ATTACHMENT I

PROPOSED TECHNICAL SPECIFICATION CHANGES

Power Authority of the
State of New York
May, 1978

ATTACHMENT II
ERRATA TO SAFETY EVALUATION
SUBMITTED APRIL 7, 1978

Figure 3.10-2 Hot Channel Factor Normalized Operating Envelope.

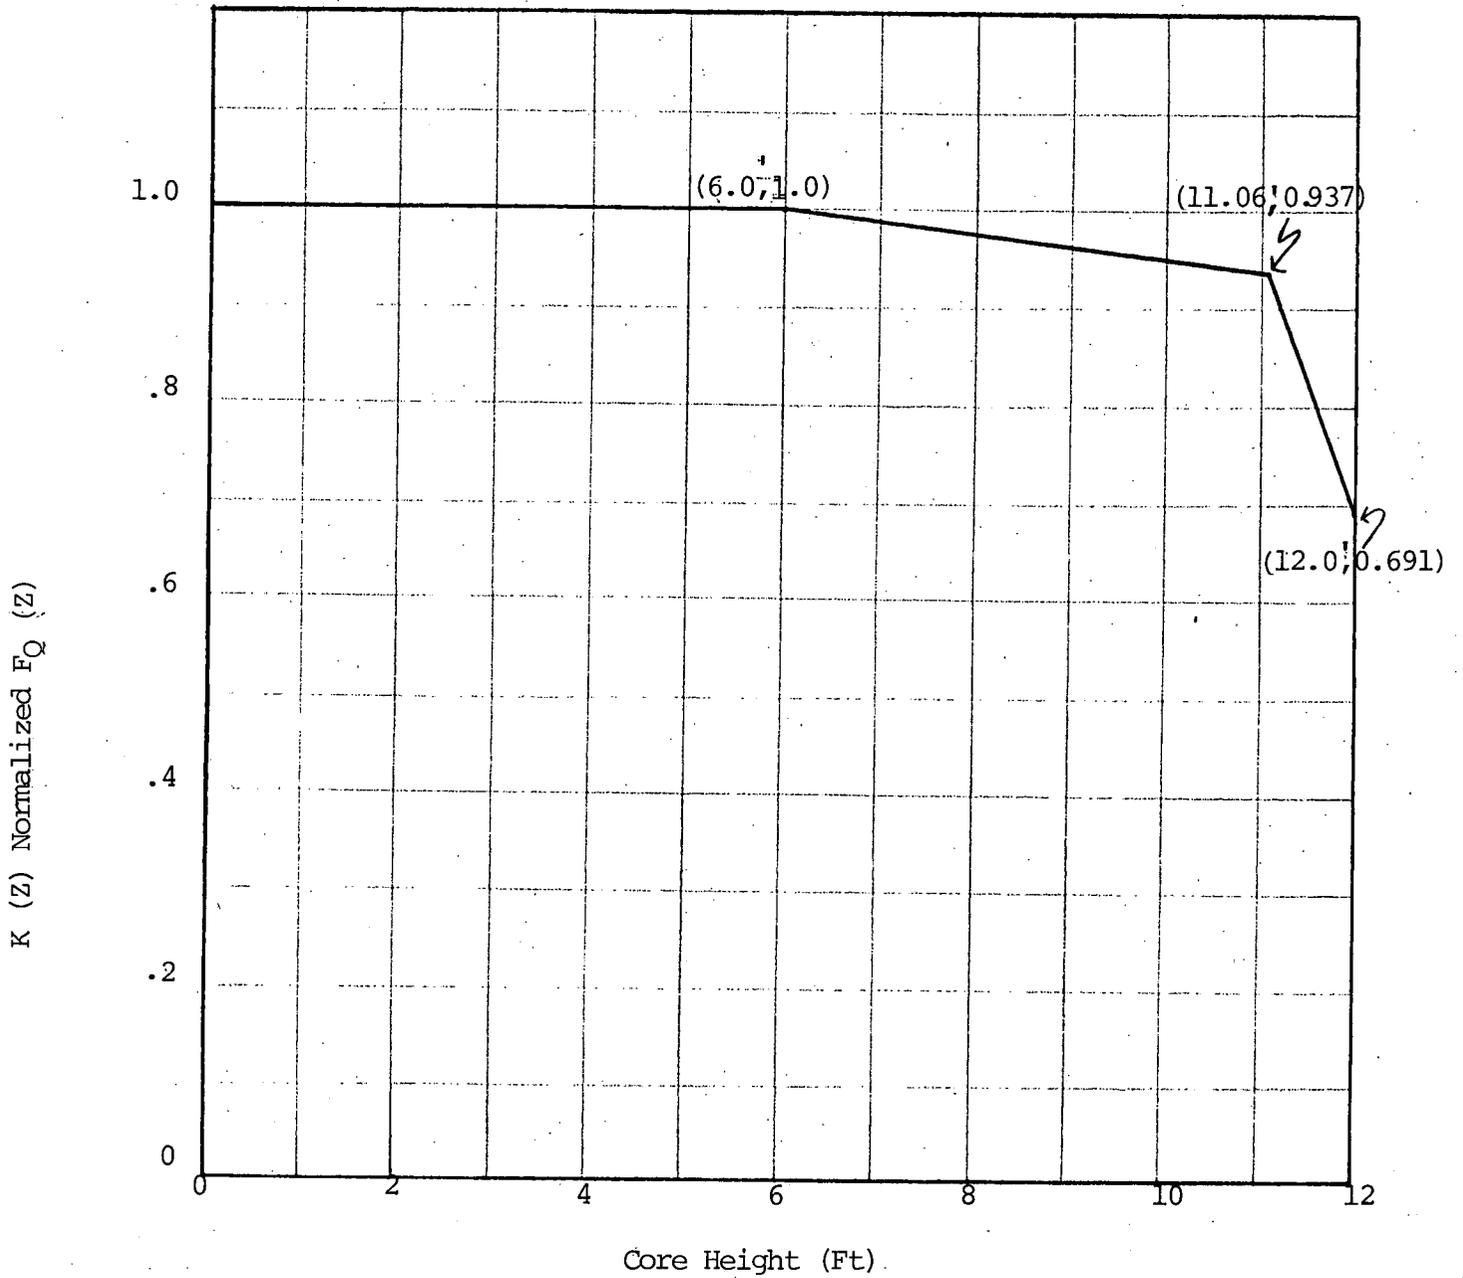
$$F_Q(Z) \leq (2.17/P) \times K(Z) \text{ for } P > 0.5$$

where P is the fraction of full power at which the core is operating. K(Z) is the fraction given in Figure 3.10-2 and Z is the core height location of F_Q .

An upper bound envelope of 2.17 times the normalized peaking factor axial dependence of Figure 3.10-2 has been determined consistent with Appendix K criteria and is satisfied by all operating maneuvers consistent with the technical specifications on power distribution control as given in Section 3.10. The results of the loss of coolant accident analyses based on this upper bound normalized envelope of Figure 3.10-2 demonstrate a peak clad temperature below the 2200 F limit. ²

FIGURE 2

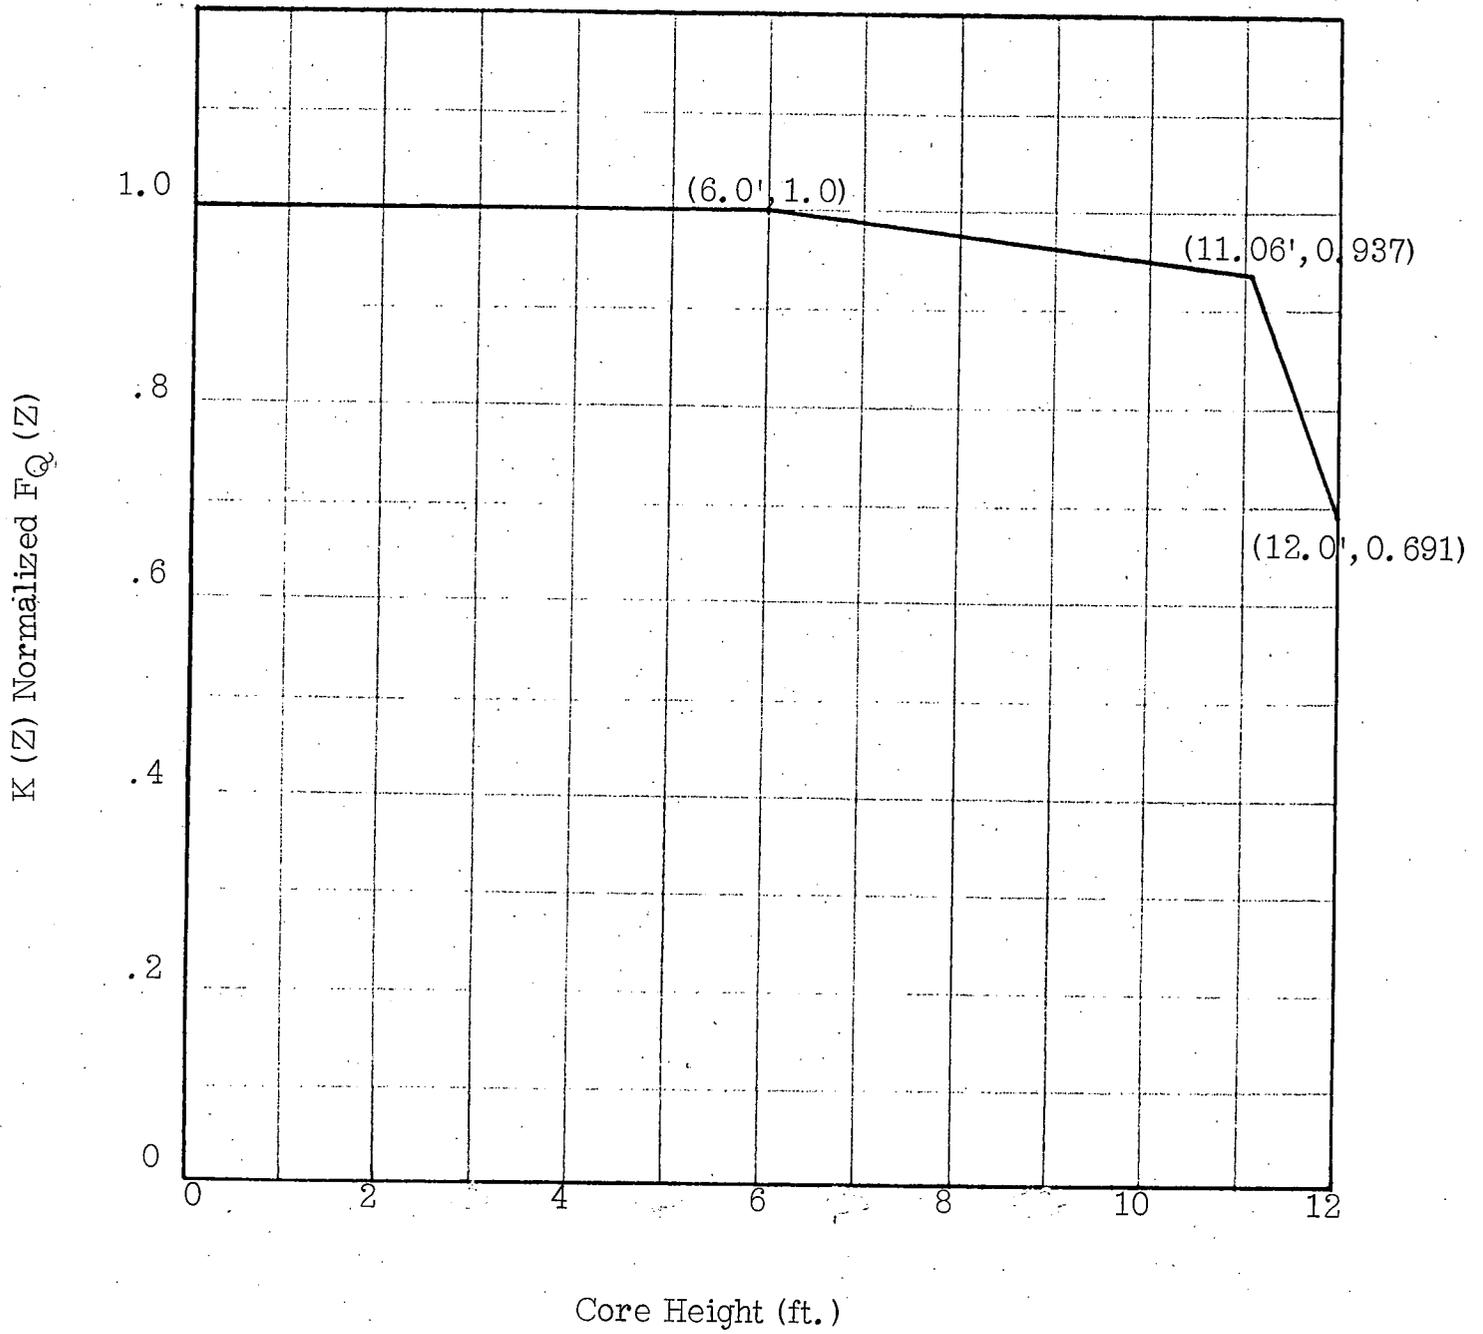
1. Page 3, paragraph 1, line 4, change from "...limit of $\leq 2.32 \times K(Z)$..." to "...limit of $\leq 2.17 \times K(Z)$..."
2. Page 5, Section 3.1 line 8, change from "... below $2.32 \times K(Z)$..." to "...below $2.17 \times K(Z)$..."
3. Page 10, Section 4.1, paragraph 2, line 2, change from "... to (12.0,0.647)..." to "...to (12.0,0.691)..."
4. Page 10. Section 4.1, paragraph 3, line 2, change from "... less than + 12.5% at ..." to "... less than +10.0% at ..."
5. Insert attached Figure 2-Hot Channel Factor Normalized Operating Envelope.
6. Insert attached Figure 3-Full Length Rod Insertion Limit 100 Step Overlap Four Loop Operation.
